802.3da PD Load Transient Test

Protecting the Mixing Segment's Power Integrity

Comment 245 Motivation

Comment 245

Figure 189-x04-9—**PDMPD** ripple voltage test fixture

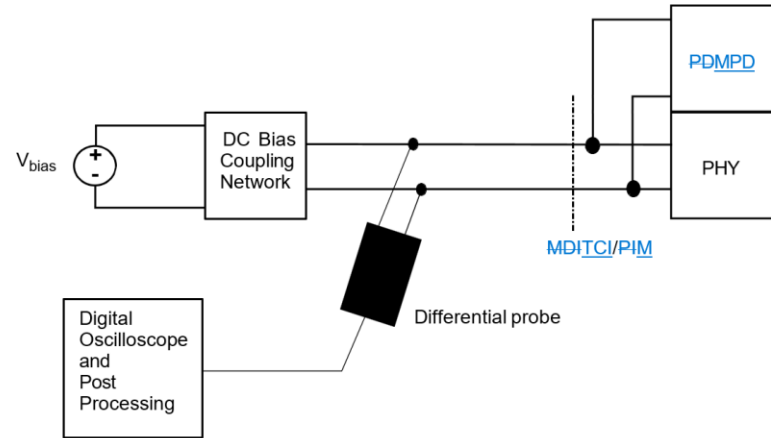
The specifications for [ripple and transients](#) MPD current slew rate dI/dt in Table 104-11189-9 [applies](#) to the voltage or current at the **PDMPD** [PIMPI](#) generated by the **PDMPD** circuitry. [Ripple and transient limits](#) are provided to preserve data integrity.

The **PDMPD** DUT is connected to a power supply through a dc bias coupling network as shown in Figure 189-x104-9. The ripple and transient specifications for a Type **A-0** or Type **C-1** **PDMPD** shall be met for all operating voltages in the range of V_{PDMPD} sourced through a dc bias coupling network with [MDTCI](#) return loss as specified by Equation (96-12188-4), and over the range of P_{PDMPD} . [A digital oscilloscope or data acquisition module with a differential probe is used to observe the voltage at the TCI/MPI.](#)
